Access Compliance Report

Public Rights-of-Way

(Curb Ramps)

Intersection ID: 46758	Main Street: CUMBERLAND_COVE_DR	Cross Street: SUPERIOR_ST	Location: E
ADA ID: 341AF6DEF8E1	Ramp Type: PerpDiag	Initial Pass/Fail: Fail	Overall Compliance: No
Severity Score: 8.75			
Codes/Mitigation Info/Possible Solution		Field Measurements/Component Compliance

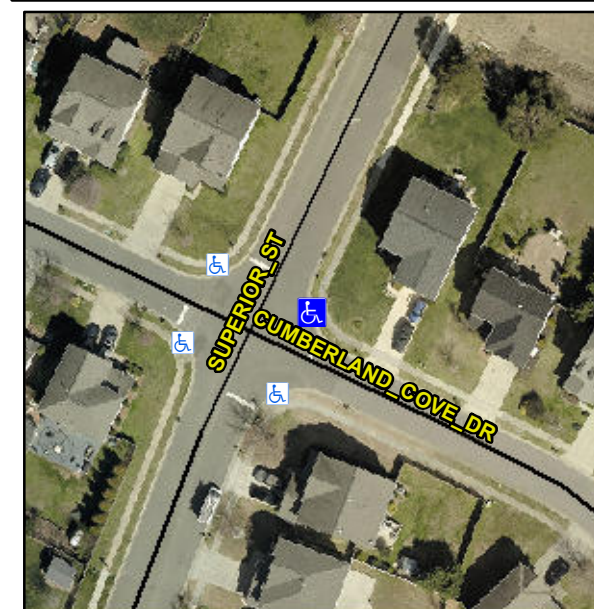
Compliance	Description	Data	Compliance	Description	Data
N/A	Ramp Length (in)	47.0	Yes	Ramp Slope (%)	7.6
No	Ramp Width (in)	42.5	Yes	Ramp XSlope (%)	1.8
N/A	Flare Type LT	N/A	N/A	Flare Type RT	N/A
N/A	Flare Slope LT (%)	N/A	N/A	Flare Slope RT (%)	N/A
N/A	Flare Traversable LT?	N/A	N/A	Flare Traversable RT?	N/A
N/A	Landing Length (in)	N/A	N/A	DWS Provided?	N/A
N/A	Landing Width (in)	N/A	N/A	DWS Contrast?	N/A
N/A	Landing Slope (%)	N/A	N/A	DWS Length (in)	N/A
N/A	Landing X Slope (%)	N/A	N/A	DWS Full Width?	N/A
N/A	Landing Curb? (Y/N)	N/A	N/A	DWS Offset (in)	N/A
N/A	Shared Landing?	N/A			
N/A	Gutter Ponding?	N/A	N/A	Gutter Slope (%)	N/A
N/A	Gutter Lip Ht (in)	N/A	N/A	Gutter X Slope (%)	N/A
N/A	Painted X Walk1?	No	N/A	Painted X Walk2?	No
	X Walk 1 Direction	To NW		X Walk 2 Direction	To SW
N/A	X Walk 1 Width (in)	N/A	N/A	X Walk 2 Width (in)	N/A
	X Walk 1 Slope (%)	0.7		X Walk 2 Slope (%)	4.2
	X Walk 1 X Slope (%)	3.0		X Walk 2 X Slope (%)	1.3

N/A	Ramp inside XWalk1?	N/A	N/A	Ramp inside XWalk2?	N/A
	Road Slope (%)	2.6	N/A	Clear Space?	N/A
	Road X Slope (%)	1.4	N/A	Clear Space to XWalk (in)	N/A
N/A	Any Obstructions?	N/A	N/A	Storm Grate/Utility Hazard?	N/A
	Obstruction Type			Storm Grate/Utility Type	
		N/A			N/A
		Yes		Surface Condition? (G/P)	Good

Remove & Replace Curb Ramp With Two New Directional Ramps or Equivalent.
